VISTA POINT SUBDIVISION
SAN ANTONIO, TX, BEXAR COUNTY

MASTER DEVELOPMENT PLAN Revised 798 -A

Re: Vista Point Subdivision MDP # 798-A

The City Staff Development Review Committee has reviewed Vista Point Subdivision Master Development Plan M.D.P.# 798A. Please find enclosed a signed copy for your files. Your plan was accepted, however please note the following:

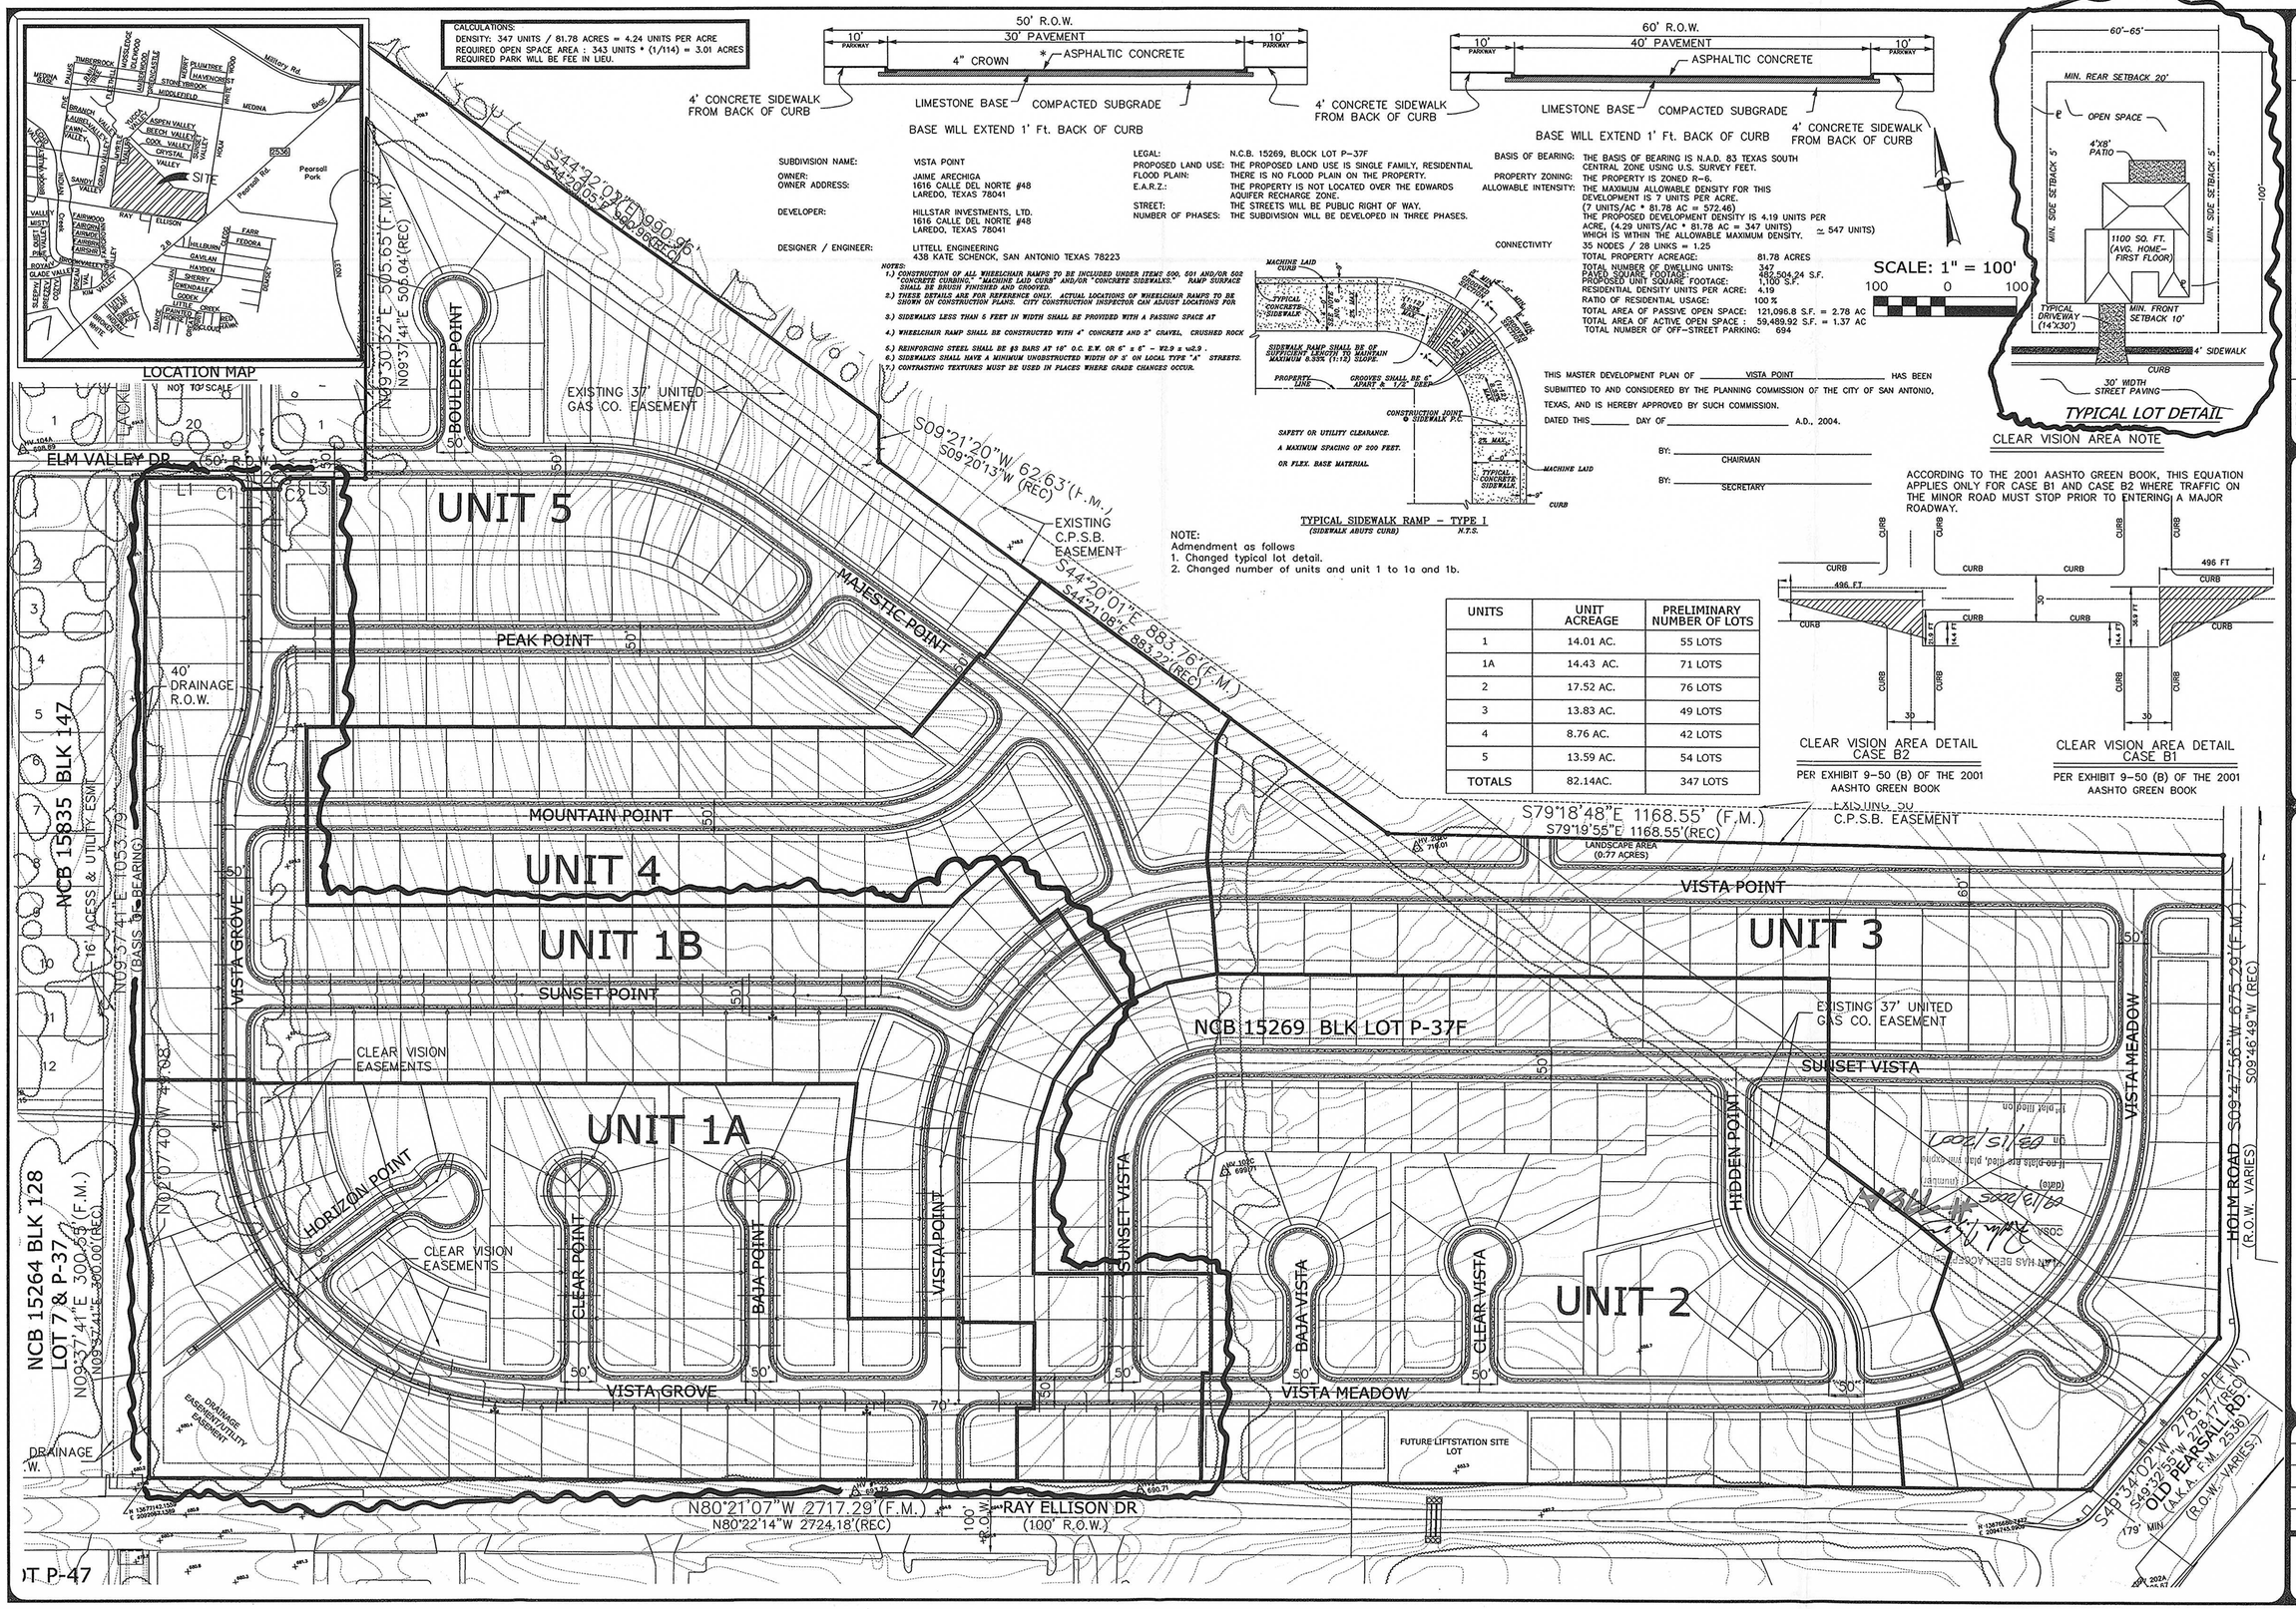
- Street and Drainage has approved with the following conditions:
    1. Remove all specific reference to pavement structure on the typical street sections. Utilize generic labeling for surface course, base course and subgrade.

2. The following item should be addressed during the respective platting process: Evaluate potential clear vision issues and respective traffic calming requirements for the intersection of Majestic Point and Peak Point.
